2010 Annual Revision Cycle

National Electrical Code® Committee Report on Proposals

This Report contains the proposed amendments for the 2011 National Electrical Code® for public review and comment prior to October 23, 2009, and for consideration at the NFPA June 2010 Association Technical Meeting

Figure 90.2

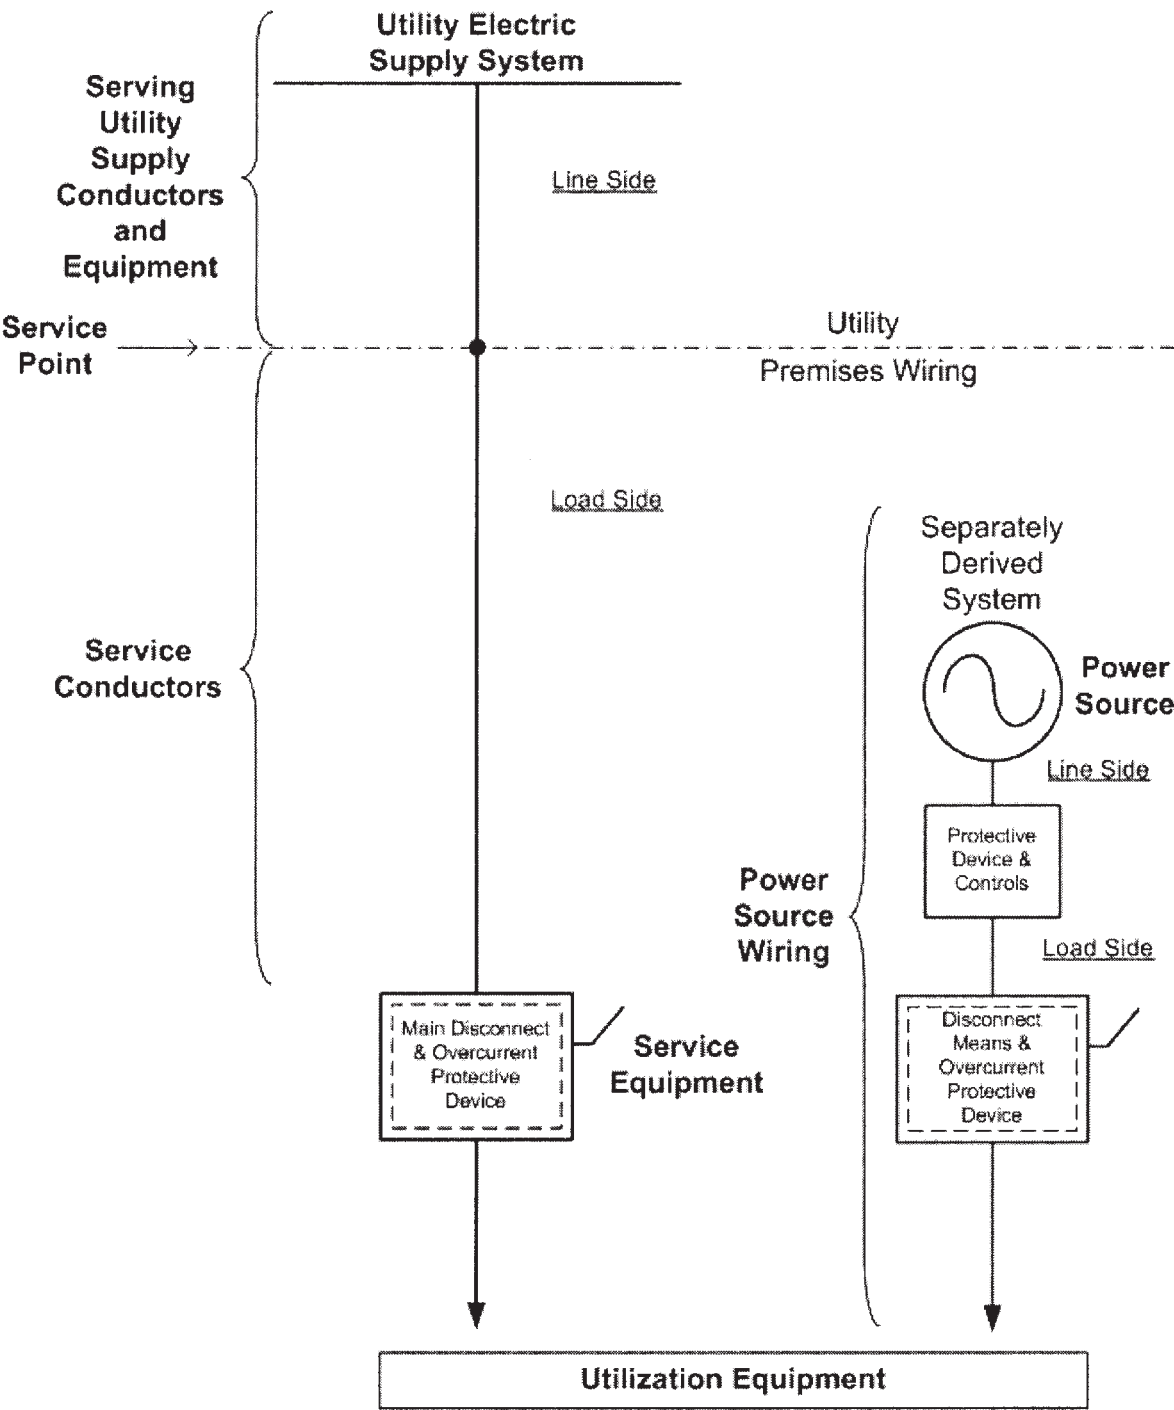
Specifically, the rationale for this change is to add an illustrative figure to 90.2 to provide visual clarity where the NEC applies to premises wiring meeting the supply facilities under exclusive control of utilities at the service point and to separately derived systems that are not connected to a service point. The location of the service point and utility equipment to provide electric service to premises wiring is dependent upon the governmental or regulated serving utility's local requirements or those of a private utility under governmental oversight or conditions of service (e.g. tariffs with service applications).

Panel Statement: The proposal does not enhance clarity or usability. Proposed Figure 90.2 does not apply to all installations and does not clarify exclusive control.

Figure 90.2

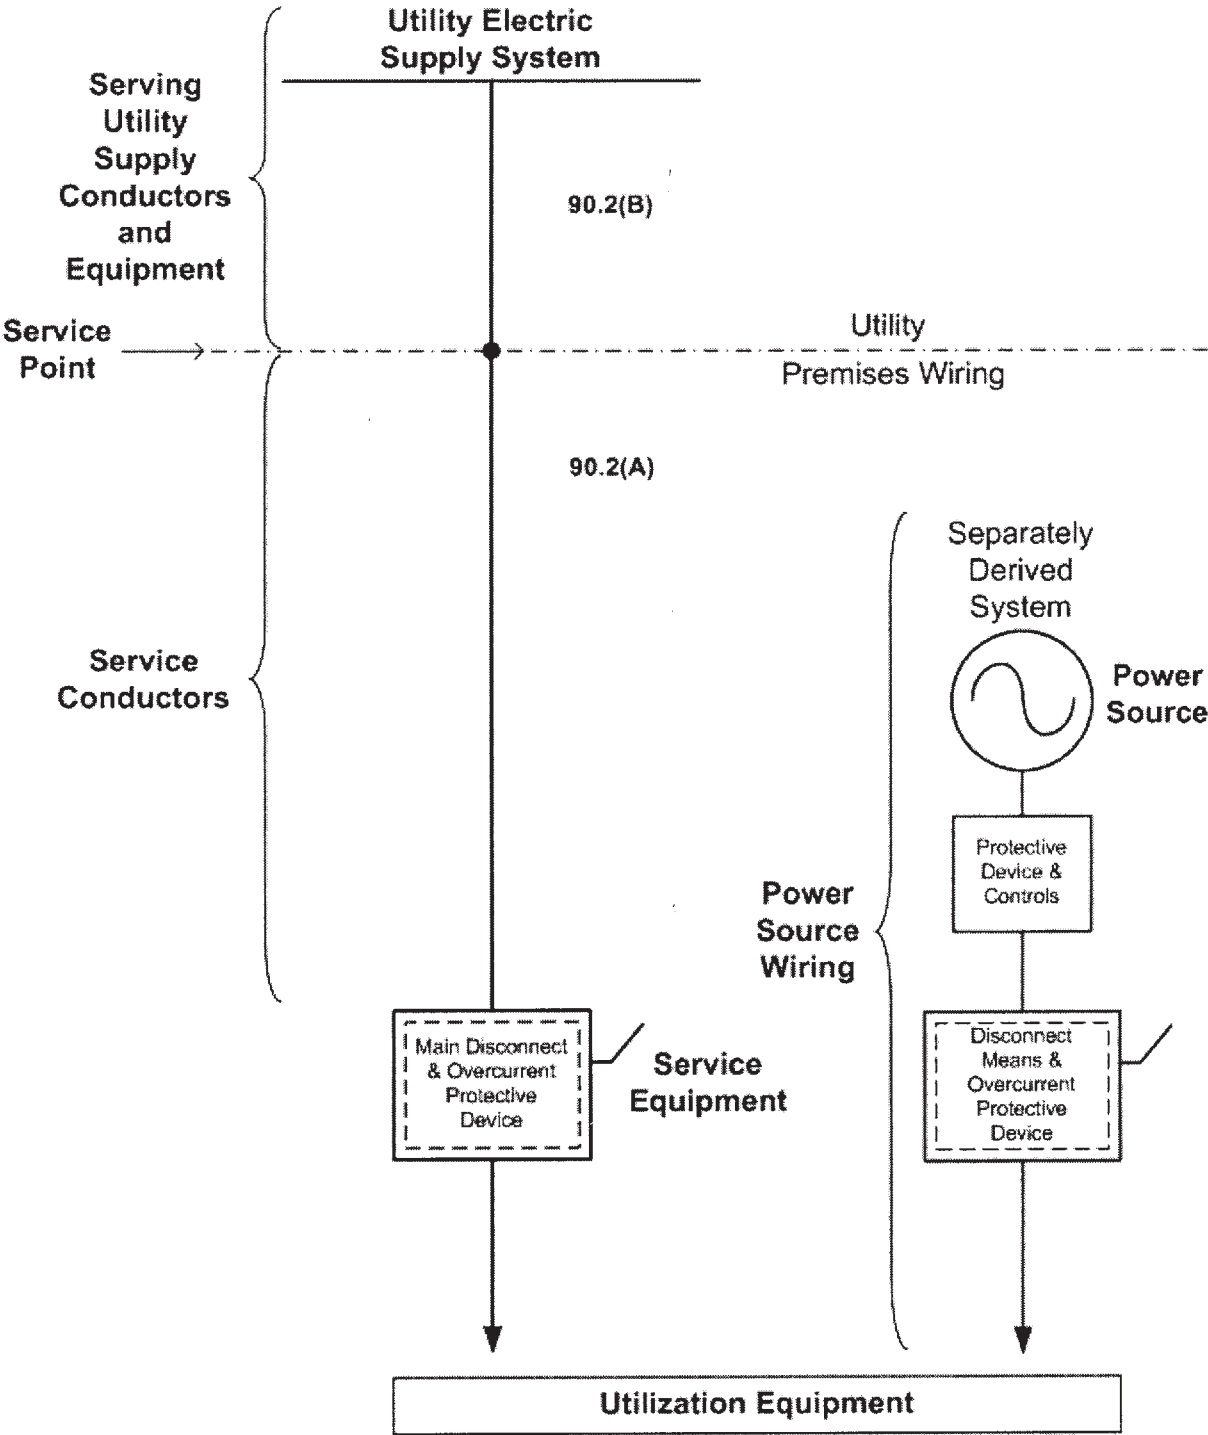
ANTHONY, M.: The addition of the phrase "premises wiring" does add clarity, in our view.

Exhibit 110.12 The 30 in. wide front working space, which is not required to be directly centered on the electrical equipment if space is sufficient for safe operation and maintenance of such equipment.

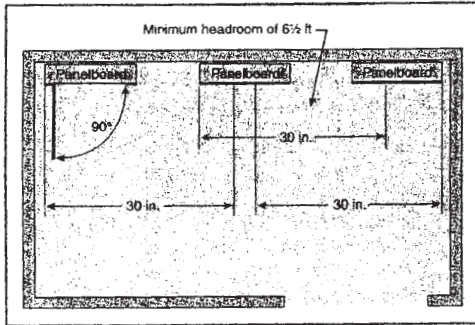
Substantiation: 1. The rules regarding space around equipment is one of the most consulted and most difficult parts of the NEC. This illustration, scanned from the 2005 NEC Handbook, will help NEC users.

Exhibit 110.14 Basic Rule, first paragraph. At least one entrance is required to provide access to the working space around electrical equipment [110.26(C)(1)]. The lower installation would not be acceptable for a switchboard rated 1200 amperes or more.

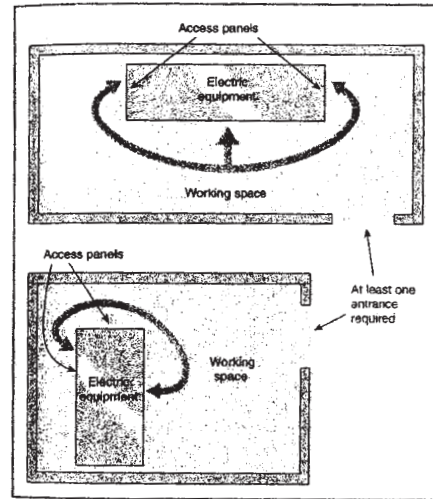
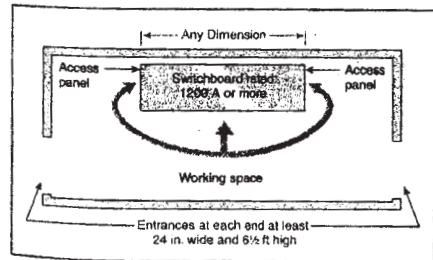
most consulted and most difficult parts of the NEC. This illustration, scanned from the 2005 NEC Handbook, will help NEC users.

Exhibit 110.19 The two distinct indoor installation spaces required by 110.26(A) and 110.26(F): the working space and the dedicated electrical space.

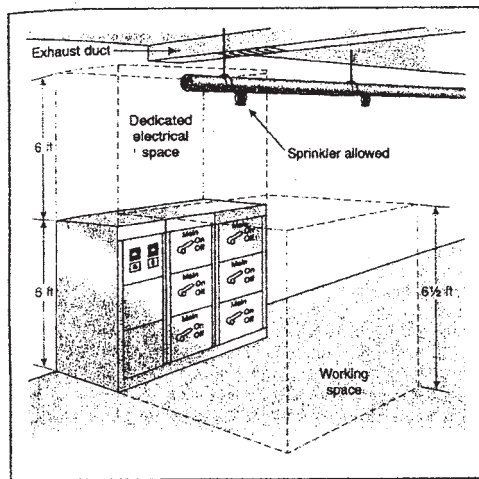
Substantiation: 1. The rules regarding space around equipment are one of the most consulted and most difficult parts of the NEC. This illustration, scanned from the 2005 NEC Handbook, will help NEC users.

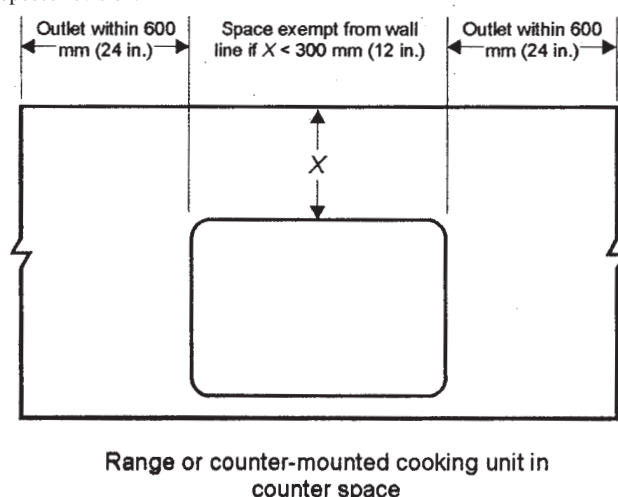
Replace the upper drawing in Figure 210.52(C)(1) with the following proposed revision:

Revise the text in Figure 210.52(C)(1) to read, "Figure 210.52(C)(1) Determination of Area Behind a Range, or Counter-Mounted Cooking Unit, or Sink."

The upper drawing in Figure 210.52(C) needs to be revised as shown as most commonly, counter-mounted cooking units, rangetops and sinks do not extend from the face of kitchen counters. And, that is not the issue being addressed. This section addresses whether the appliance or sinks create a separation of the counter top for the purpose of determining the appropriate placement of receptacle outlets.

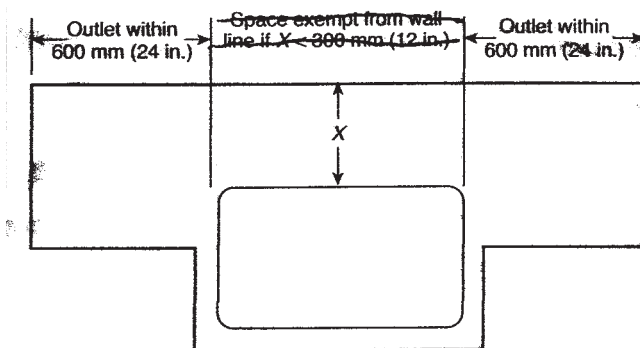
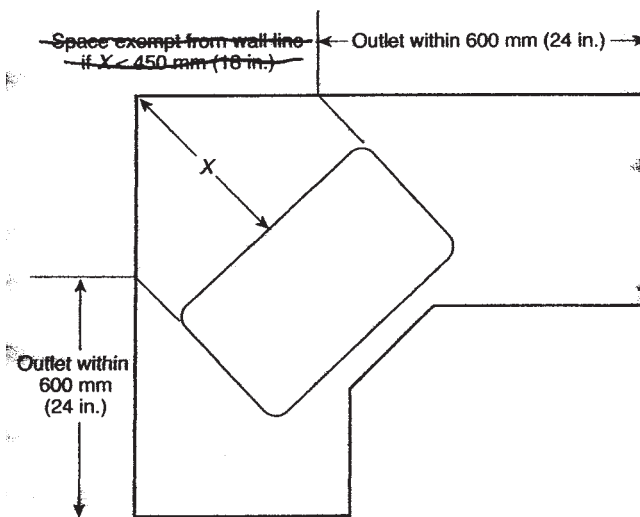
Recommendation: Add the following sentence at the end of (C)(1):

Sidewalls that run perpendicular to the counter shall be permitted to be omitted from this measurement.

Substantiation: A receptacle installed along the back wall of a counter space is usually close to 24 in. from the front edge of a counter. This would serve as a clarification as to where the measurement for receptacle layout begins, the back corner of the wall counter space. As this section is currently written, there are at least two different ways of interpreting it, I am advancing the most prevalent interpretation in the field.

4-57 Log #2141 NEC-P04
(Figure 230.1)

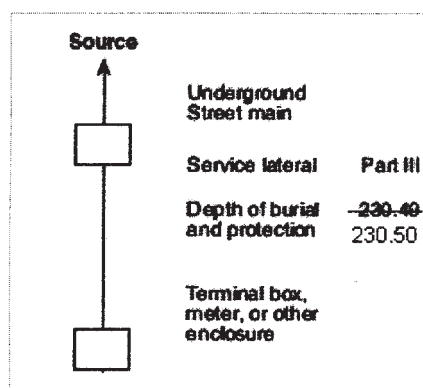
The word "Source" near the top of Figure 230.1 Services is incorrect, it should be deleted and replaced with the words "Serving Utility".

Panel Meeting Action: Accept

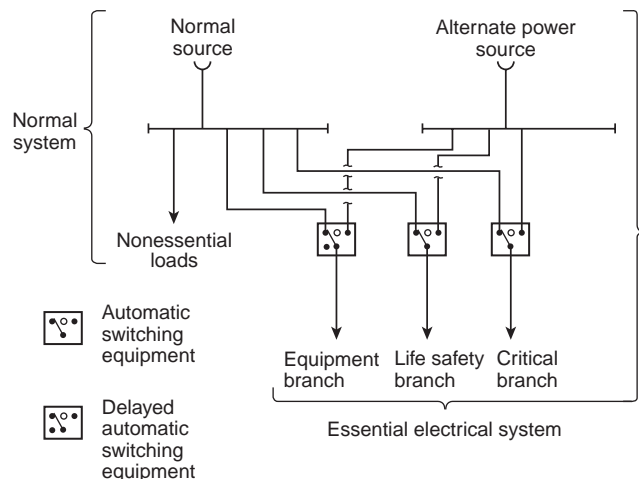
Recommendation: Qualify FPN Figure 517.30, No. 1 as follows:

FPN Figure 517.30, No. 1 Hospital – Minimum Requirement (greater than 150 kVA) for Transfer Switch Arrangement.

Substantiation: FPN Figure 517.30, No. 1 is only the minimum requirement if greater than 150 kVA. Otherwise, FPN Figure 517.30, No. 2 is the minimum requirement.

Panel Statement: Figures 517.30 No. 1 and 517.30 No. 2 are FPN figures. The NEC Manual of Style permits figures in an FPN and are not enforceable.

FPN FIGURE 517.30 No. 1

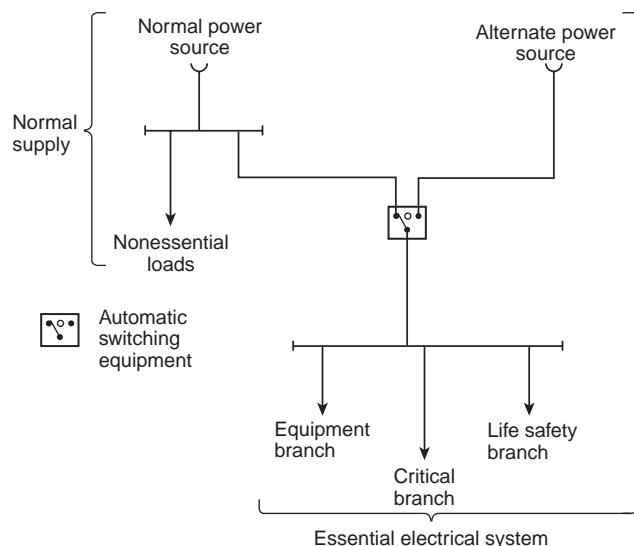
Recommendation: Revise FPN Figure No. 1 and No. 2 to revise text in the diagram by replacing the word system to branch in the phrase Equipment branch and in FPN Figure No. 1 remove the reference to Emergency system and bracket. See the attached diagram for clarification.

Substantiation: This is necessary to correlate with action and statement on proposal 15-72.

Figure 701.18 Clarification of Selective Coordination Requirements

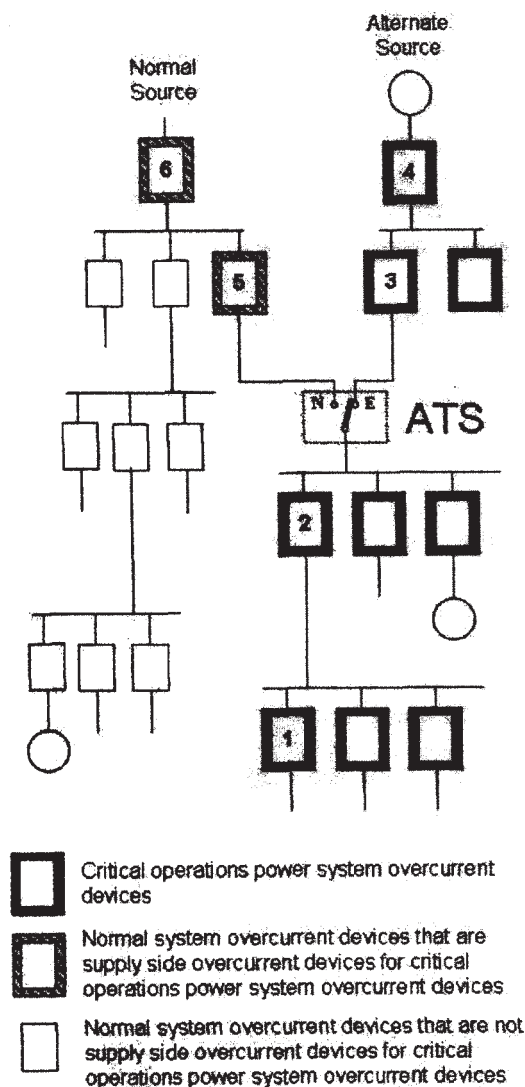
Substantiation: This proposal is an attempt to clarify the confusion concerning selective coordination requirements.
